**From:** [REDACTED]  
**Sent:** 25/07/2023 7:54:12 AM  
**To:** Council Northernbeaches Mailbox  
**Cc:** Joe Hauser; Les Randolph; [REDACTED]; Steve Filletti; Ernie Webber; Deidre Mcalinden  
**Subject:** DA 2023 0868 37 HAY STREET COLLAROY NSW 2097 WRITTEN SUBMISSION: LETTER OF OBJECTION SUBMISSION: TULLOCH  
**Attachments:** 37 HAY WS.pdf;

# SUBMISSION

RE: DA 2023 0868  
37 HAY STREET COLLAROY NSW 2097  
WRITTEN SUBMISSION: LETTER OF OBJECTION  
SUBMISSION: TULLOCH

**LES & MARIE RANDOLPH, 35 HAY STREET, COLLAROY  
DEVASTATING VIEW LOSS**

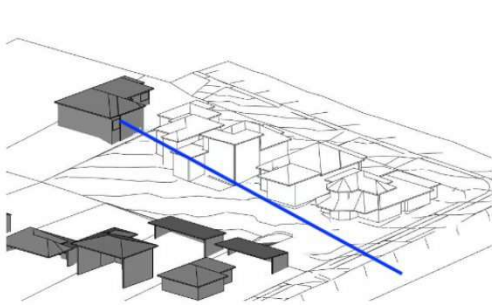
Extent of Loss: Total loss of ocean view from viewpoint
